**Staff Issue Report**

January 29, 2016

**SUBJECT:** Seismic Qualification of Fire Suppression System at the Plutonium Facility, Los Alamos National Laboratory

**Figure 1: Example of fire suppression piping underneath unsecured equipment.**

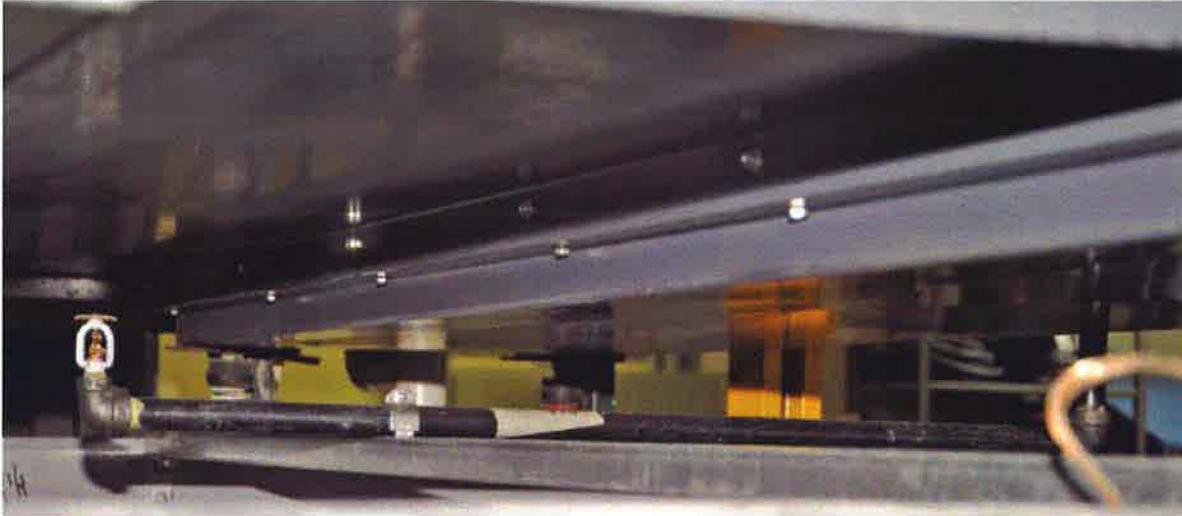
During the November 30, 2015, walkdowns, the staff review team found that a number of the seismic interaction concerns identified by LANS in 2010 still existed [5]. Most notably, large air handlers were installed above fire suppression piping without adequate seismic anchorage and bracing (Figure 1). Damage to the fire suppression piping from falling equipment, such as these air handlers, would lead to a loss of water and hydraulic pressure in the facility, impairing its function after a seismic event. The site's structural engineers could not provide the staff review team with a technical justification for why this condition does not pose a seismic interaction concern. They acknowledged that not all seismic interaction effects have been dispositioned for the FSS.

**Figure 2: Condition of laboratory ceiling as evaluated (top) and current configuration (bottom).**

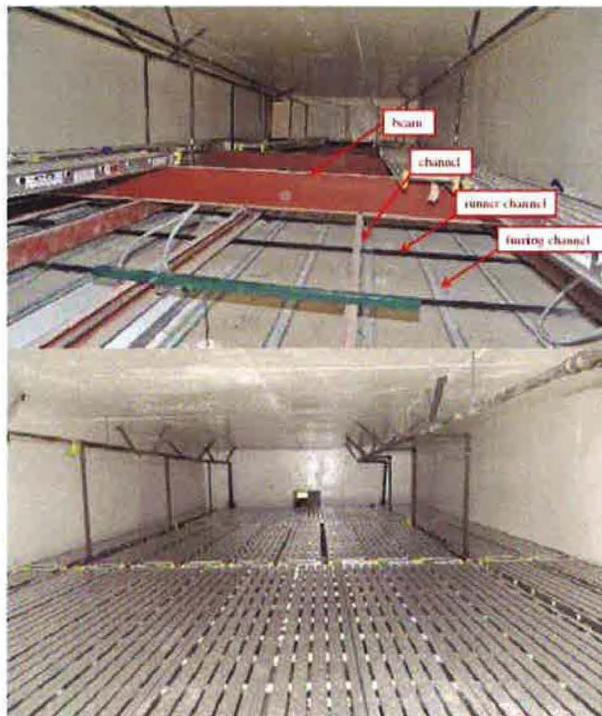
*Configuration Changes to Laboratory Ceilings*—During walkdowns of PF-4, the staff review team viewed one of the laboratory ceiling spaces where LANS has made fire suppression and structural upgrades to the roof girders. Damage or collapse of parts of the laboratory ceiling during an earthquake may damage fire suppression piping and prevent the proper heat activation of sprinkler heads during a post-seismic fire. The staff review team noted that LANS installed significant metal decking that is supported by the laboratory ceiling (Figure 2). This differs from the facility configuration assumed in the seismic evaluation performed in 2011 by LANS's subcontractor [6]. Facility engineers told the staff reviewers that these changes are intended to be permanent.

When asked if this significant increase in dead load and seismic mass added to the laboratory ceilings had been accounted for, LANL staff engineers said that they had not updated this calculation with the configuration changes made since 2011, but believed the added decking would not exceed the dead load assumptions used in the calculations. In further discussions, LANS engineers estimated that the metal decking mass will not challenge the assumed miscellaneous loads on the laboratory ceiling. This condition was not formally evaluated before installation of the decking, and is a lapse in configuration management of the laboratory ceiling. The *Nuclear Safety Management Rule* (10 CFR Part 830) requires evaluating the impacts of configuration changes on safety-related SSCs before they are made [7]. Consistent with the rule, the staff believes that unanalyzed conditions, such as the metal decking, should have been evaluated through the LANS Unreviewed Safety Question process.
